DUNELAND SCHOOL CORPORATION

2018 RENOVATIONS AT: BAILLY ELEMENTARY SCHOOL

800 S. 5TH STREET, CHESTERTON, INDIANA 46304
 TRIA PROJECT#: 17-065

1 PARTIAL FIRST FLOOR PLAN
1/8" = 1'-0"

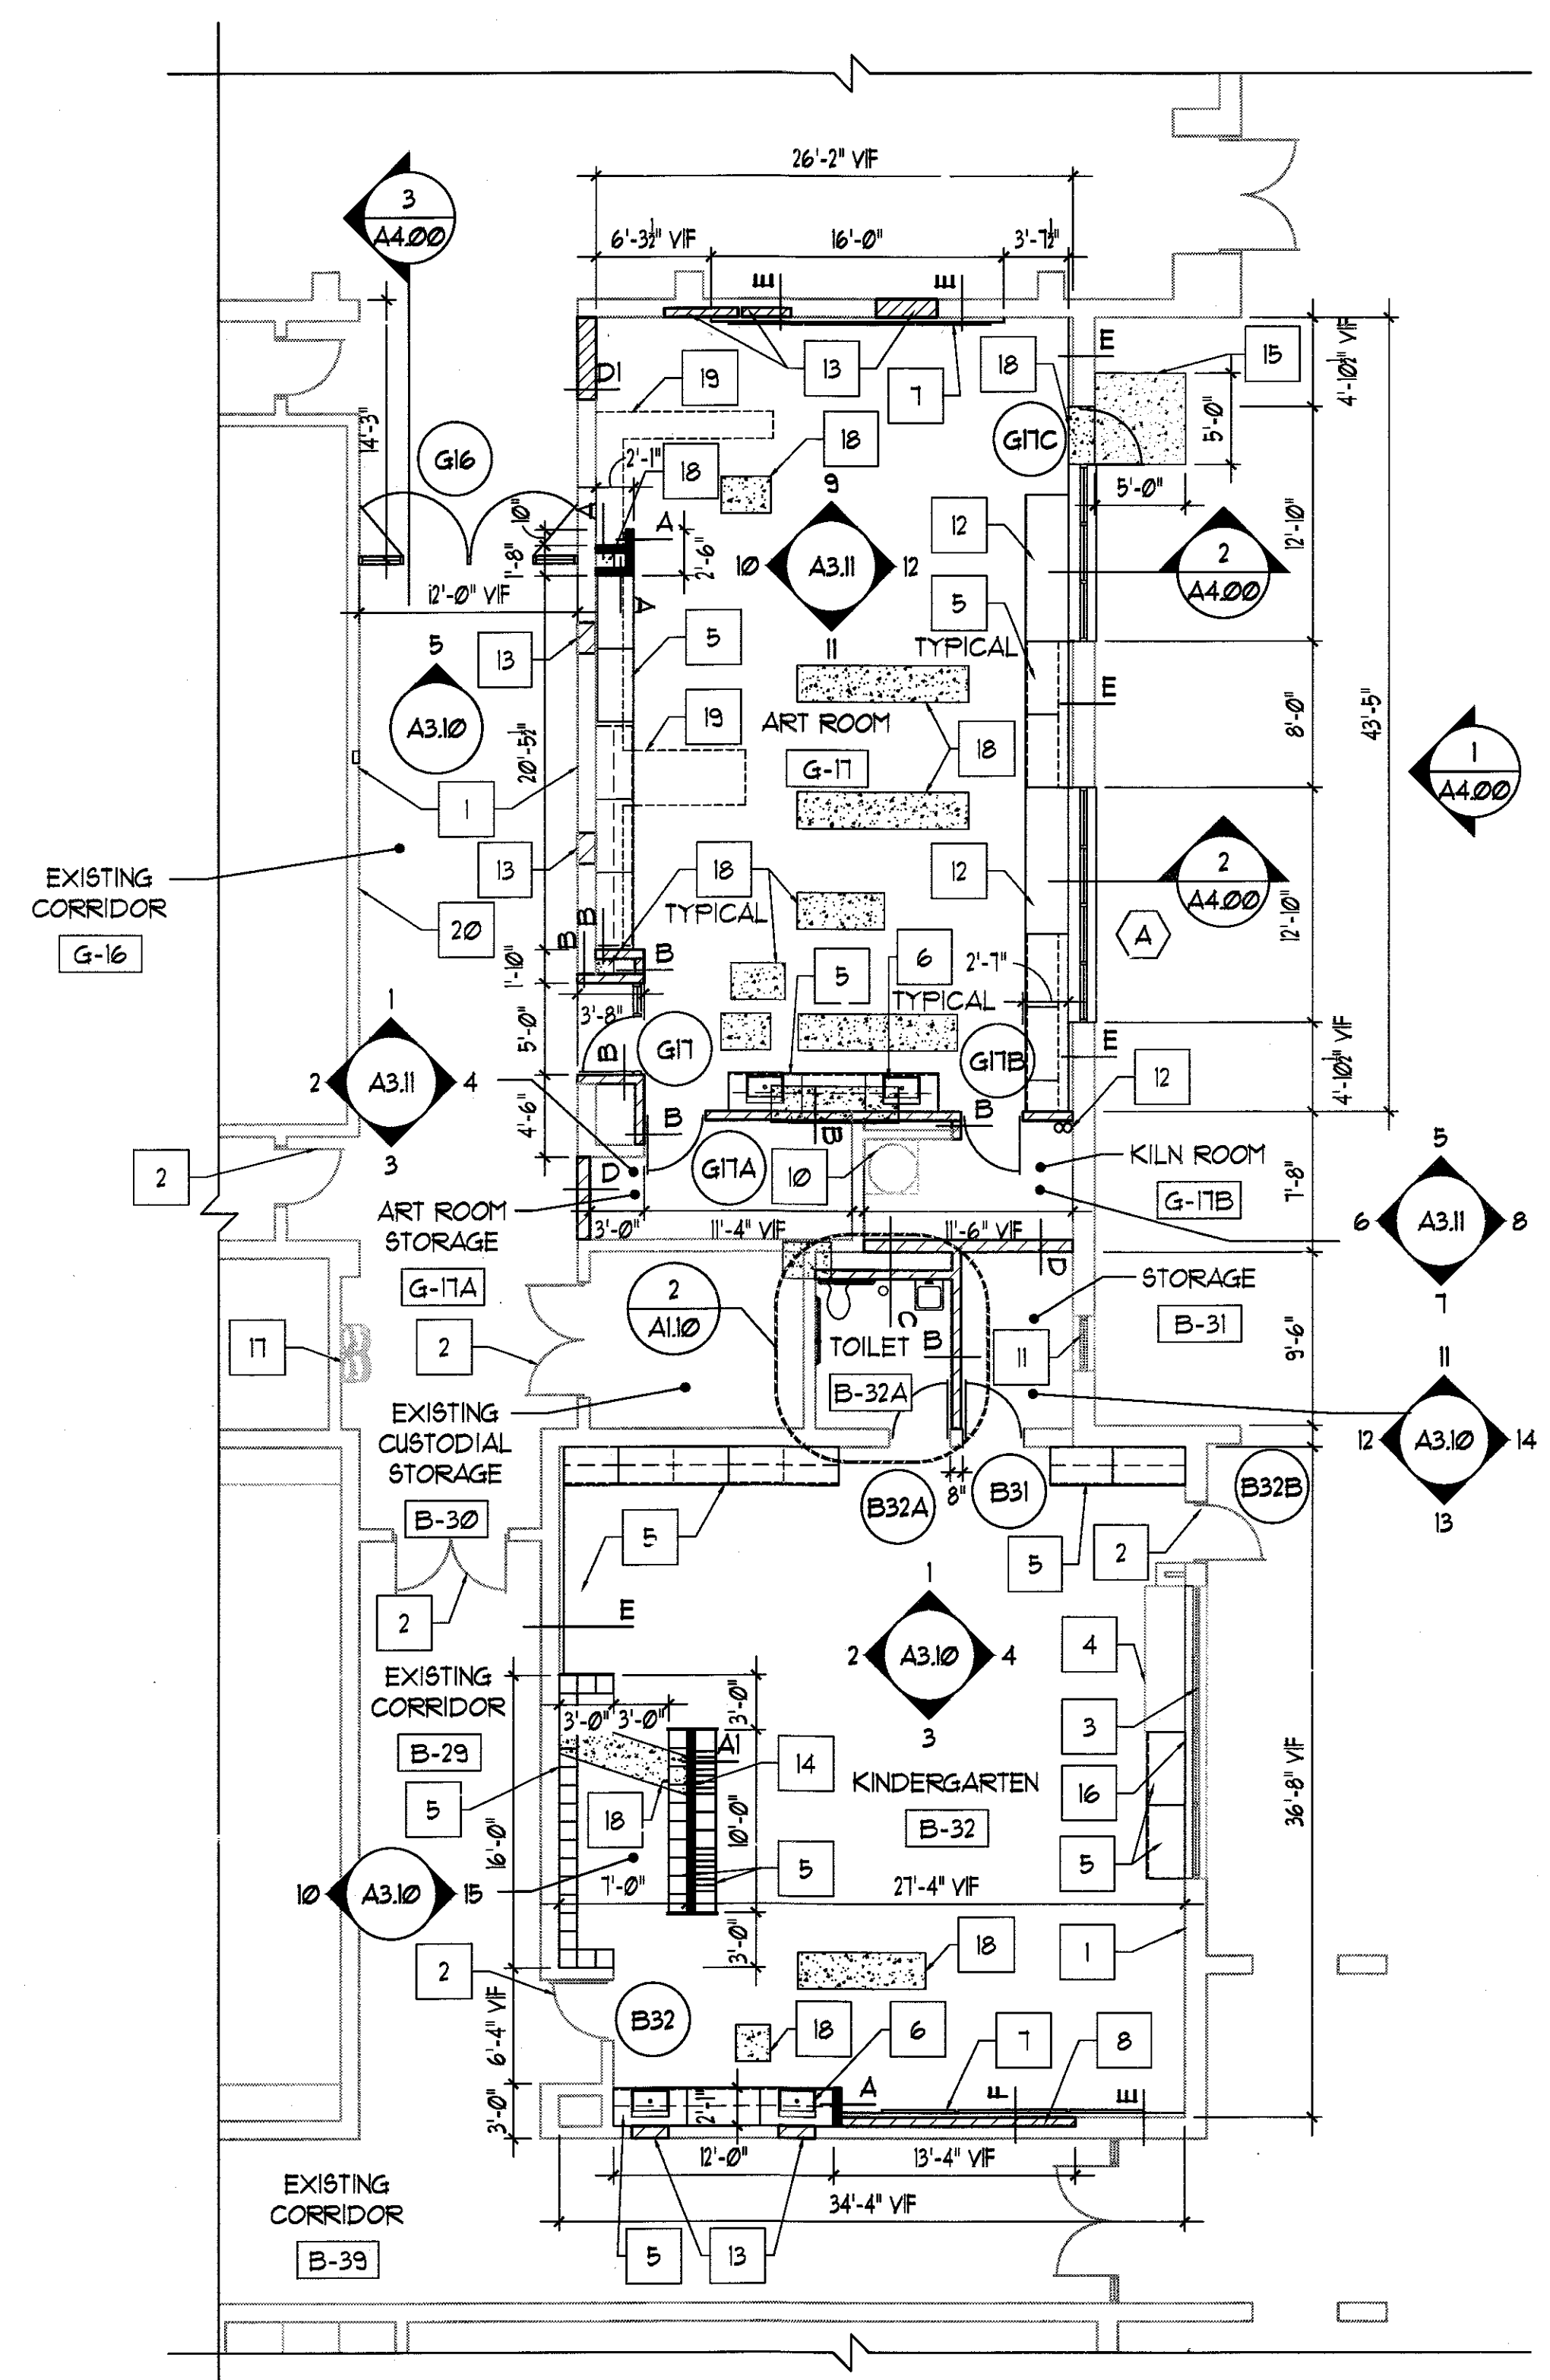
RFI #7: ALL DOOR HARDWARE AND COMPONENTS -
SATIN BRONZE (US610)

1 PARTIAL FIRST FLOOR REFLECTED CEILING PLAN
1/8" = 1'-0"

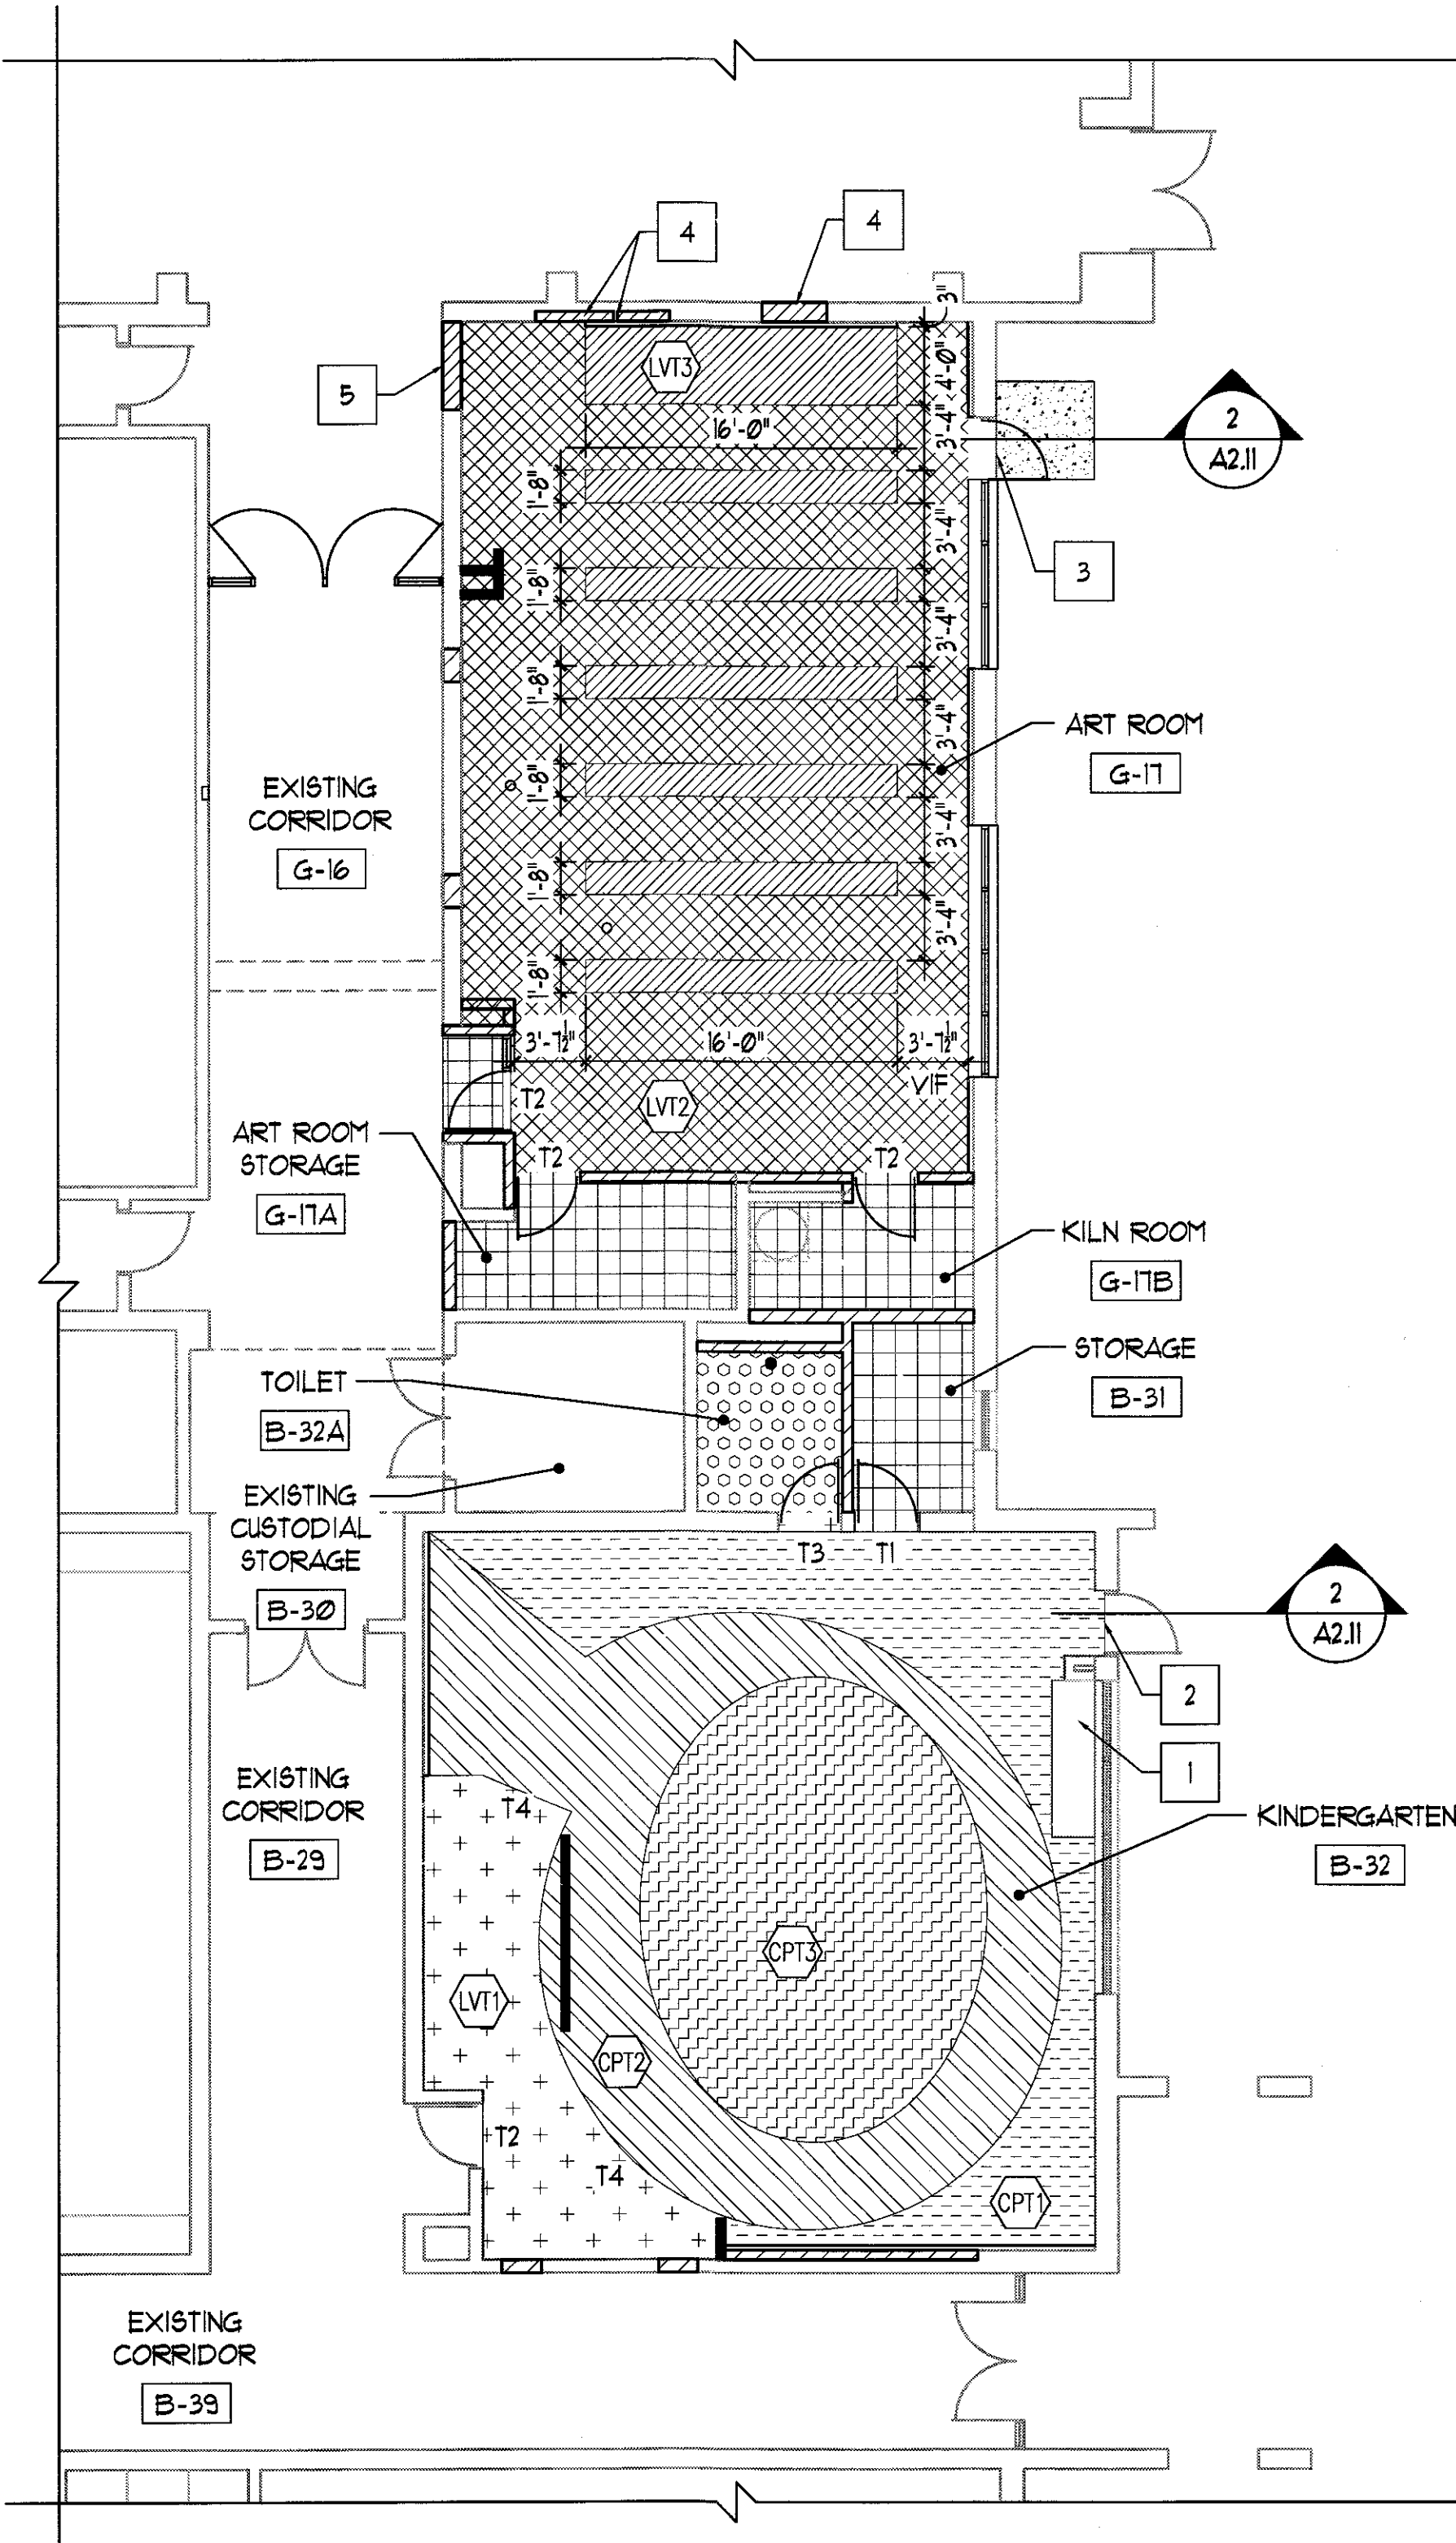
T/M 5003 EXPAND OPENING TO 20" X 20"
MECHANICAL EQUIPMENT - REFER TO MECHANICAL DRAWING
